Common Structural Rules for Bulk Carriers and Oil Tankers 1 January 2017

Technical Background for Rule Change Proposal 1 to 01 JAN 2017 version

Notes: (1) These Rule Changes enter into force on **1st July 2018**.

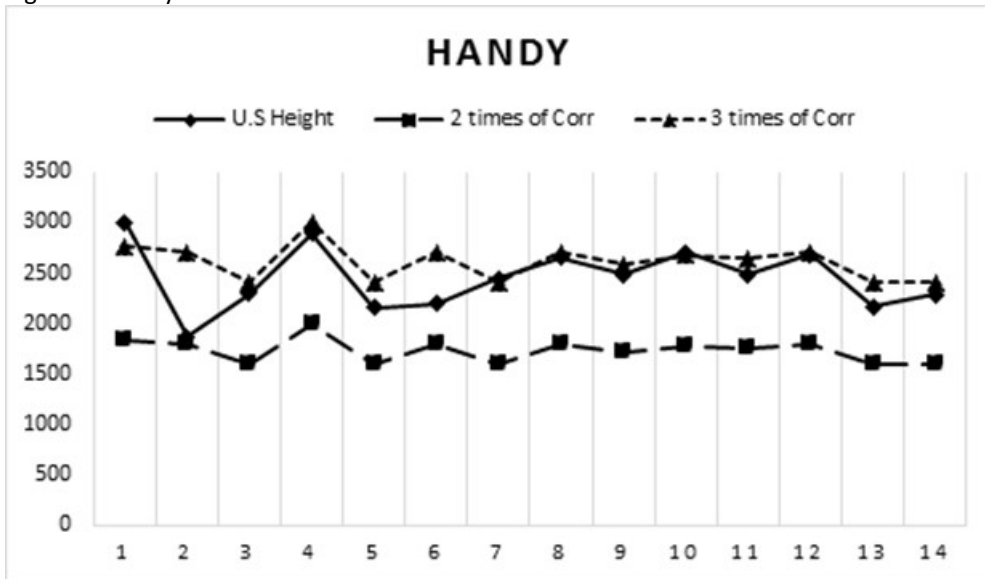
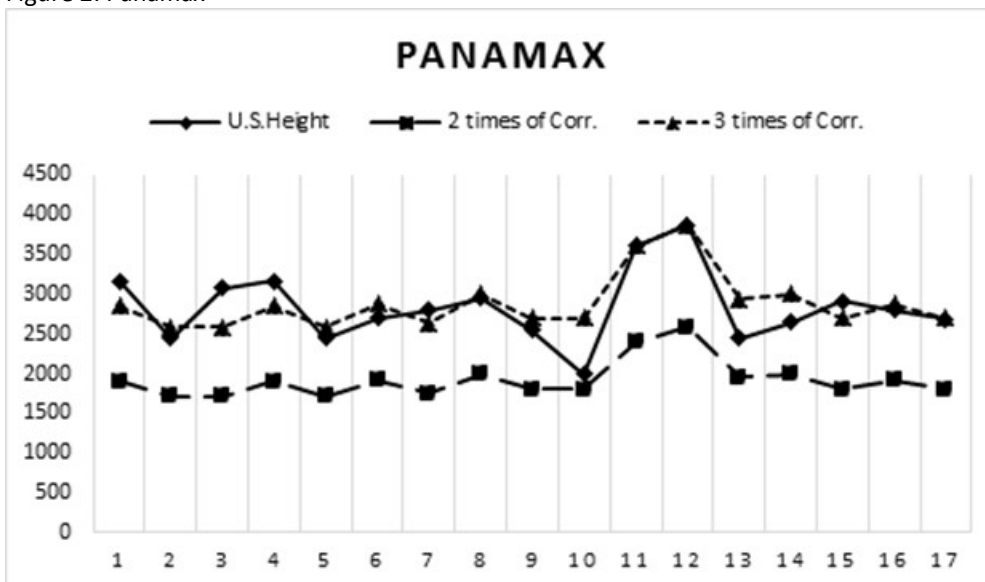
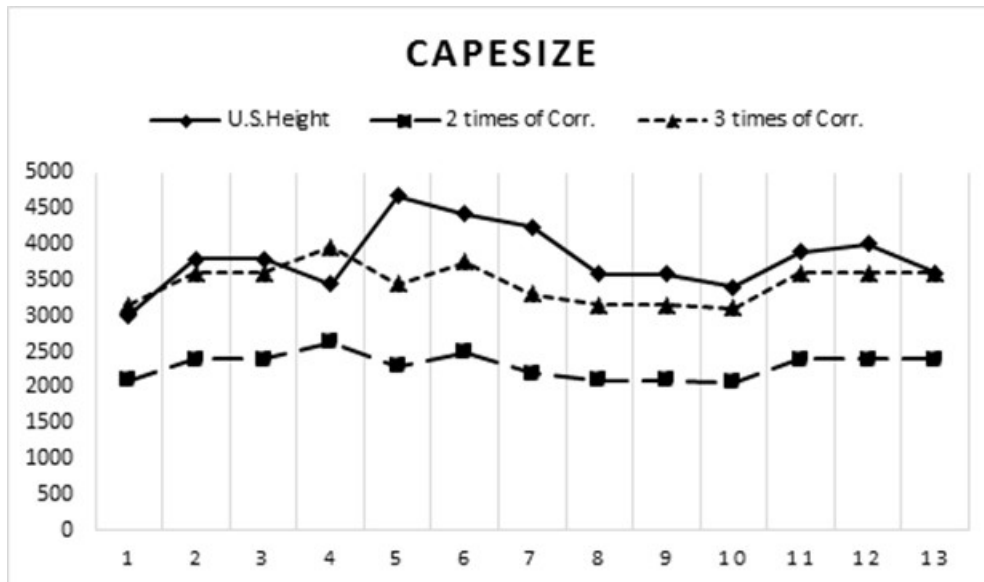
The proposal is to clarify the requirements of the upper stool height.

In many existing bulk carriers, the height of the upper stool is higher than three times the corrugation depth because of considerations related to a vessel’s specific of structural arrangement and not lower than twice the corrugation depth (see figures)

As the height of the upper stool for many existing bulk carriers is found to be not lower than twice the corrugation depth, this requirement is updated accordingly.

In addition, the proposal is to clarify the height of upper stool for rectangular stools.

Figure 1 Transom Structure Plan

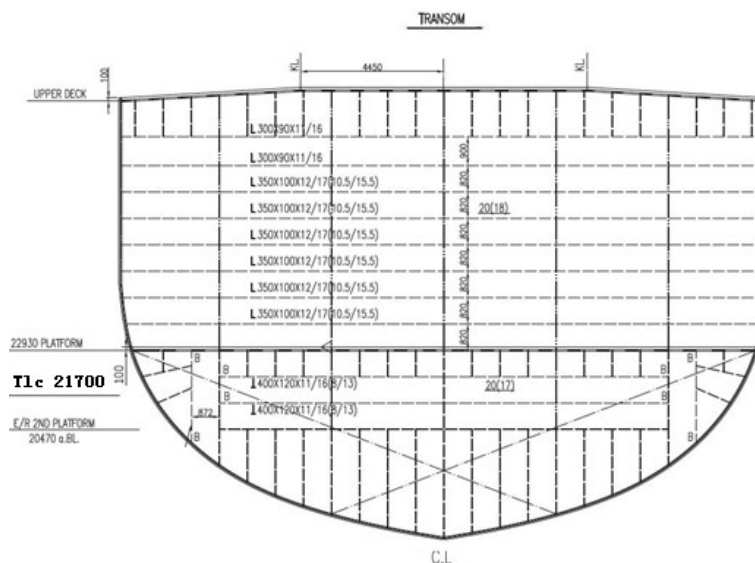
The proposal is to clarify the y coordinate of the load point of the transom for the external dynamic pressure to avoid misunderstanding which is applied to the structure of the transom.

According to TB Report "EDW Definition of Extreme Loads" [6.1.1], the formula of the hydrodynamic pressure, "P_Mid", is based on the amplitude at midship which means that the load point is on the side shell. However, the transom is the transversal structure that envelops the aftmost end of the ship hull, and the load points on it are not on the side shell. The rule is changed to clarify the y coordinate of the load point of the transom.

- a) For the LCP with $z < T_{lc}$:
 - For P1 to P9, the hydrodynamic pressures for CSR are the same as those for RCP, because the LCPs are the same which are on the shell.
 - For P10, the hydrodynamic pressure found to be not reasonable so RCP corrected this.
- b) For the LCP with $z > T_{lc}$, P11, the pressure is not influenced by RCP.

Figure 1: Fatigue Lives for Deck Connections of BC03, before and after the proposed Rule revision.

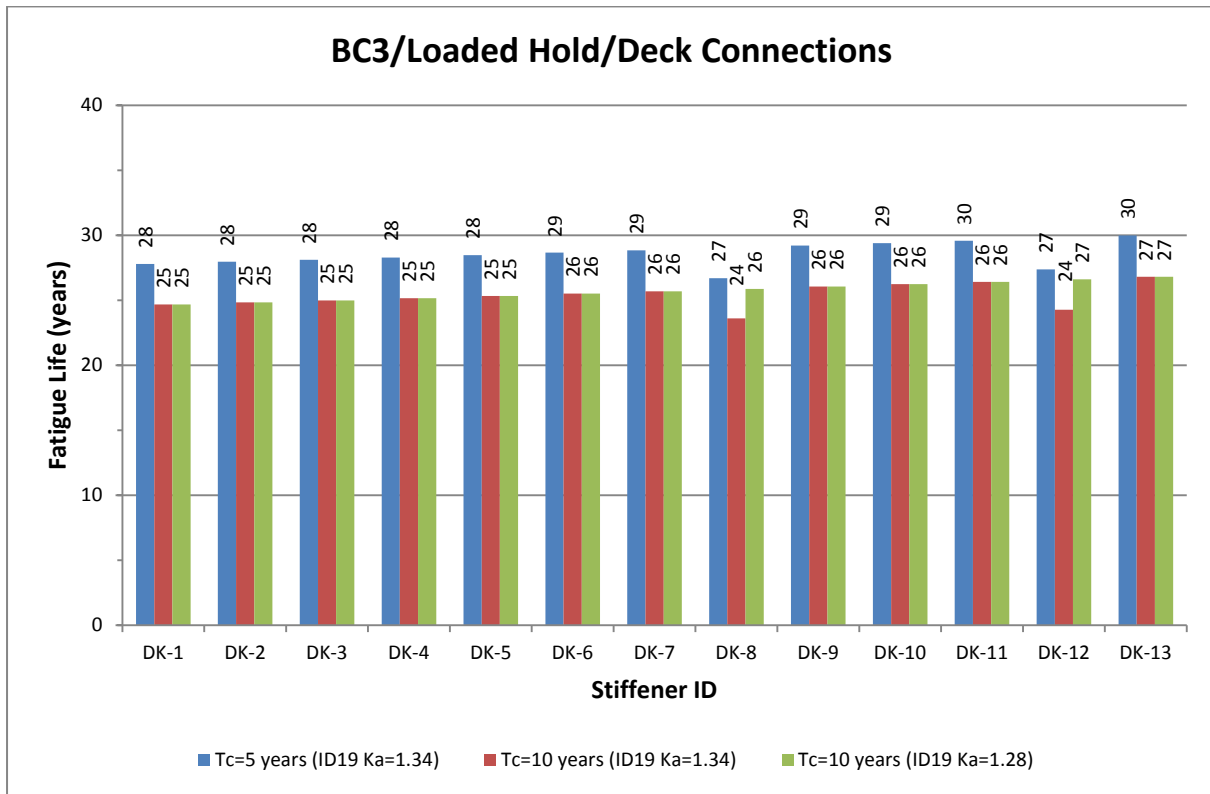
The axial stress from hull girder vertical bending is solely dominant at the deck, therefore the lowest fatigue life at a deck stiffener over the extent of the selected hold is determined at the frame locations with the highest SCF (K_a), namely tripping bracket (ID19) for DK-8 and DK-11 and web stiffeners with double soft toes (ID5) for the remaining locations. The fatigue lives are shown in Figure 1 below.

It can be seen that the fatigue life is short of the rule required 25 years in way of DK-8 and DK-12 after incorporating the URCP revision increasing the time in corrosive environment (Tc) from 5 years to 10 years. In order to achieve the Rule required fatigue life of 25 years, it was found that the deck plate thickness needed to be increased from 35mm to 37.5mm. After the SCF for the soft toe of tripping bracket ID19 i.e. hot spot “A”, has been corrected to $K_Q=1.28$, it can be seen that 25 years can be achieved without need for such increase.

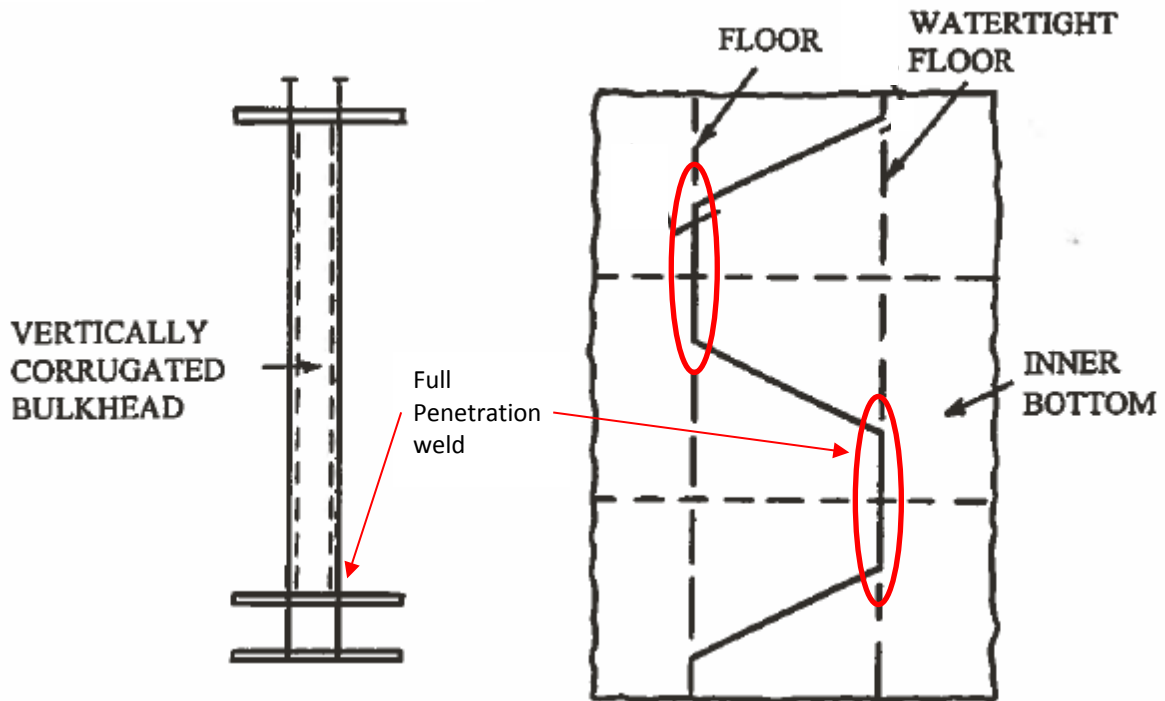
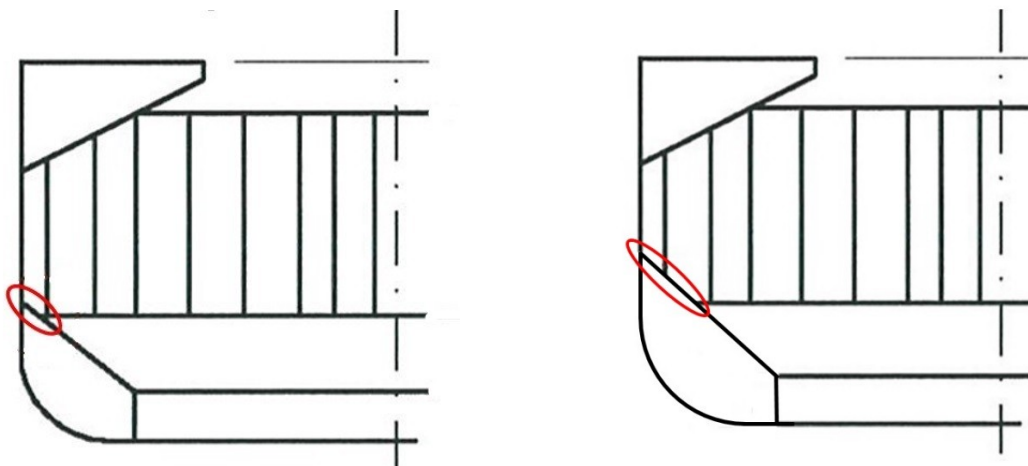
The proposal is to clarify the extent of the full penetration weld requirements.

Locations where the rules require full penetration welding were added. The main reasons for this are as follows:

The technical background offers no explanation or justification as to why partial penetration welding may suffice in these critical areas that are prone to cracking.

Furthermore, the provision giving the choice to the shipbuilder between full and partial penetration welding needs to be contrasted with IACS Rec. No.76 and Rec. No.96 which presently require the much safer full penetration welding for the repair of critical areas in bulk carriers and tankers.

Figure 1. The upper and lower connections of side frame

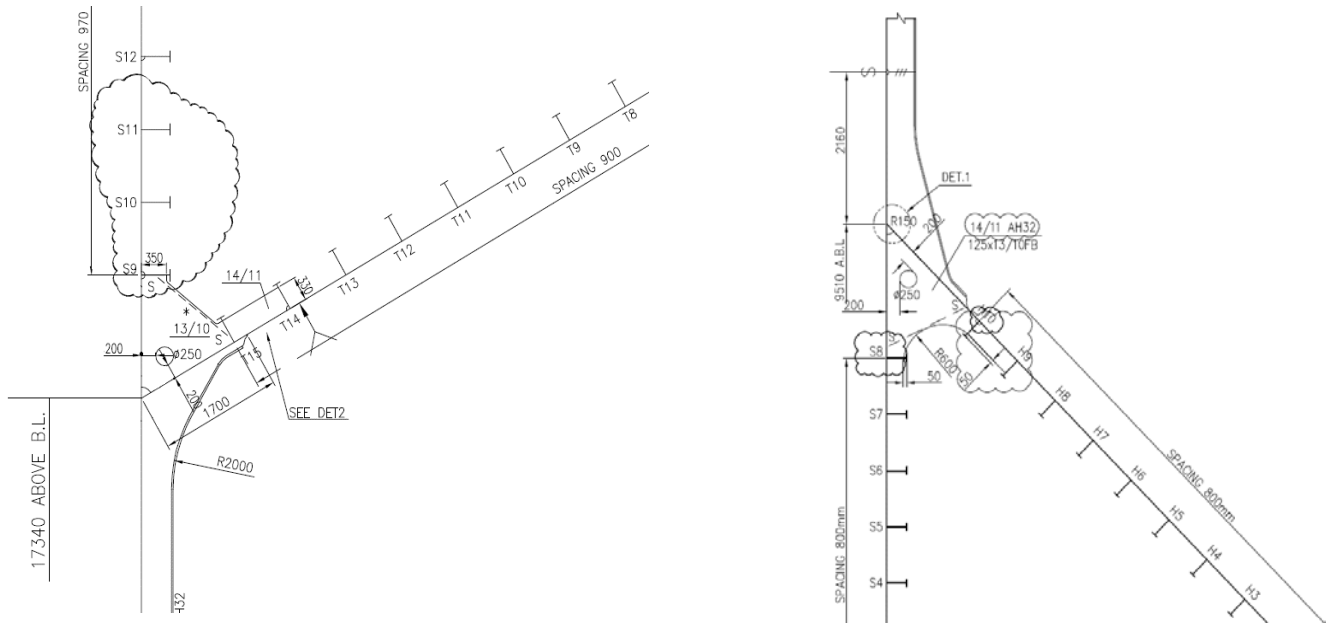
The strength requirement for net connection area of brackets for hold side frames is revised based on the technical background.

As an example, a representative Capesize bulk carrier is assessed to illustrate the consequences of the Rule Change Proposal. Cross sections of the upper and lower connections of side frame are provided as Figure 1. The pressure, space and span of the side frame are following:

According to the consequence assessment in Table 1 and Table 2, there is no impact in scantlings.
